Subject: Virgil C. Summer Nuclear Station (VCSNS) Units 2 and 3 Combined License Application (COLA) - Docket Numbers 52-027 and 52-028 Responses to NRC Request for Additional Information (RAI) Letter No. 081 Related to SRP Section 9.2.2 and Letter No. 079 Related to SRP Section 6.2.1

NRC RAI Letter No. 079 Dated March 30, 2010

NRC RAI Letter No. 081 Dated April 20, 2010

NRC RAI Number: 09.02.02-1

Figure 1
Containment Peak Pressure Sensitivity to Wet Bulb Temperature Double-Ended Cold Leg Break, Dry Bulb Temp = 115°F

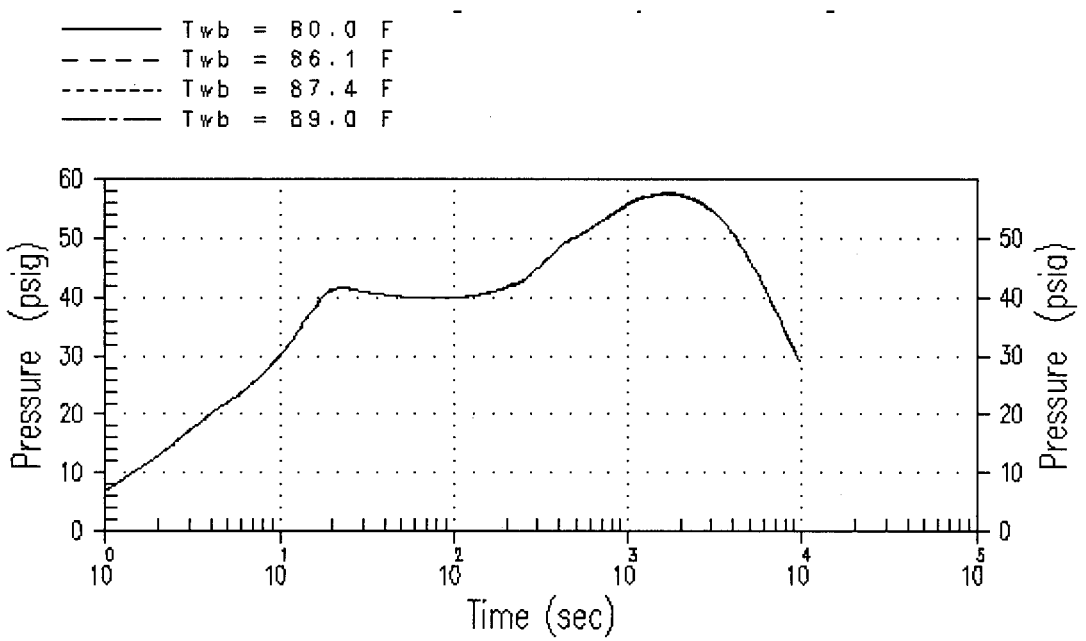
VCS DEP 2.0-2 increases the maximum noncoincident wet bulb temperature from 86.1°F to 87.3°F. The departure justification states that this increase does not change the maximum containment pressure value reported in the DCD. Please describe the analyses supporting this statement, including initial conditions, break locations, resulting peak pressure and pressure at 24 hours.

The resulting peak pressures are shown in Table 2 and Figure 1. The analyses were not run to 24 hours. However, from Figure 1 it can be determined that the ambient wet bulb temperature does not impact the long term containment pressure.

Case Name	T_{db} °F	T_{wb} °F	Peak P psig
ap1kloca	115	80.0	57.8
ap1k_dcp	115	86.1	57.88
wb87	115	87.4	57.88
wb89	115	89.0	57.90
